BARRON COUNTY HIGHWAY DEPARTMENT
APPLICATION/PERMIT FOR ACCESS DRIVEWAY TO A COUNTY TRUNK HIGHWAY

Driveways on CTH 00

#2061 10th Ave

Re: Driveway Permit

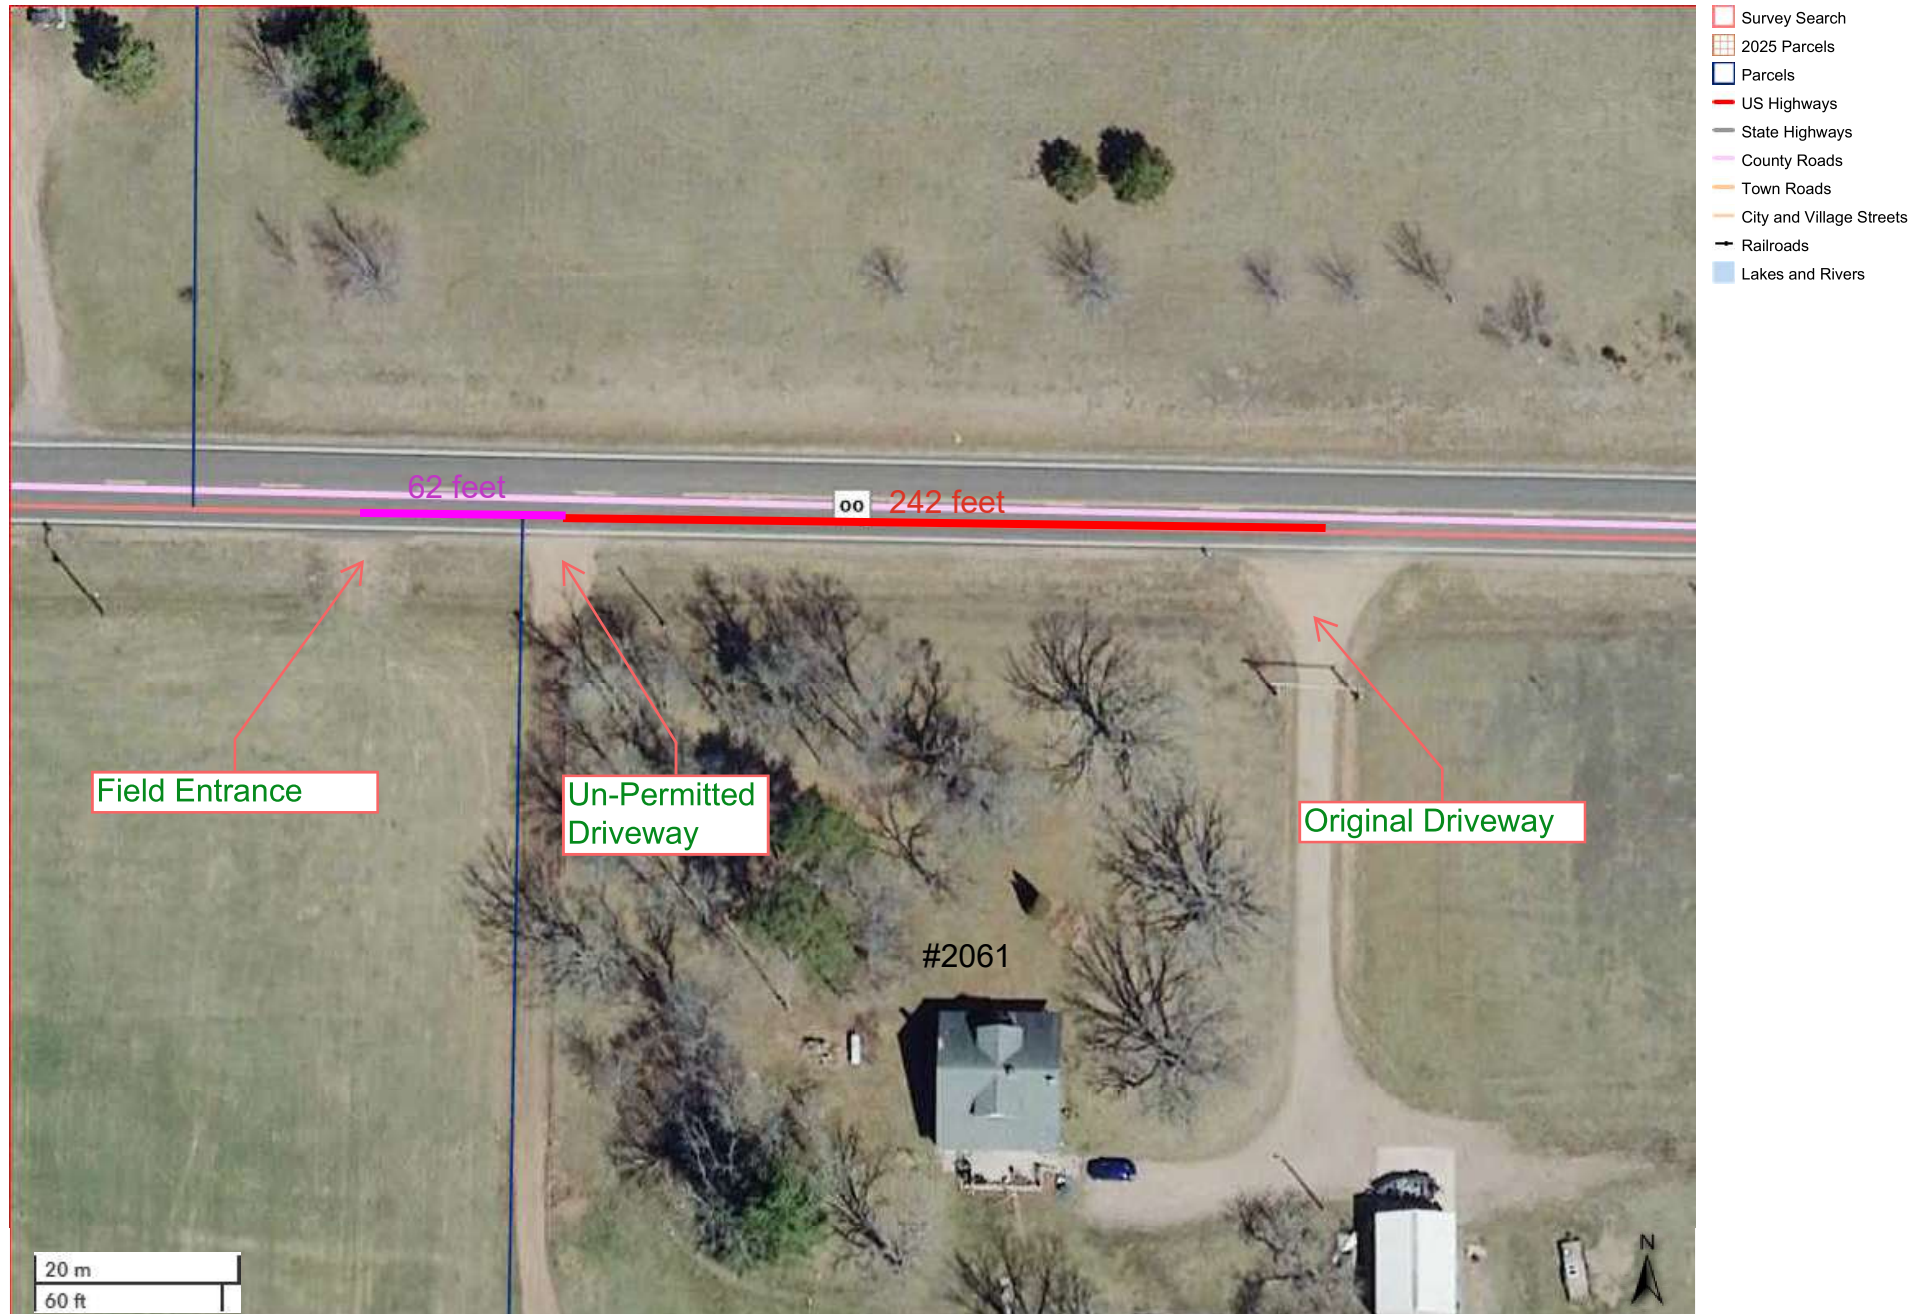
11. Inspection Pass <input type="checkbox"/> Yes <input checked="" type="checkbox"/> No		12. If no, reason <u>See below</u>		
	13. Signature of Inspector <u>M. Hecks</u>		14. Setback Requirement: <u>N/A</u> <input type="checkbox"/> 83' setback from centerline or 50' from R/W (whichever is greater) <input type="checkbox"/> 150' setback from the centerline of the closest lane of traffic on CTH SS from the Corporate Limits of the Village of Cameron to the City Limits of Rice Lake		
	Reason for Denial: <u>Spacing < 200' from Adjacent Driveway</u>		Spacing Requirement from Existing Driveways (same side of the roadway) <input checked="" type="checkbox"/> 200', except for CTH SS (see below) <input type="checkbox"/> 500' on CTH SS from the Corporate Limits of the Village of Cameron to the City Limits of Rice Lake		
Highway Committee Meeting Results: <input type="checkbox"/> Driveway Variance Granted <input type="checkbox"/> Driveway Variance Denied		Reason for Denial:		The foregoing applicant is hereby approved and permit issued by the Permitting Authority subject to full compliance by the Applicant with all provisions and conditions stated herein and on the reverse side hereof and all attachments hereto.

I am writing to inform you that your driveway permit application, dated February 10, 2024 has been denied. Per the Barron County Highway Access Ordinance, there needs to be at least 200 feet of spacing between the driveway and the next closest driveway on the same side of the highway. There is an existing driveway 60 feet west of your driveway. I've attached a copy of the permit application denial.

Failure to resolve this issue will result in removal of the driveway connection to the County Trunk Highway. I recommend working with the landowner to the west to share driveway access, thereby removing one of the driveways to conform with the 200 foot minimum spacing requirement.
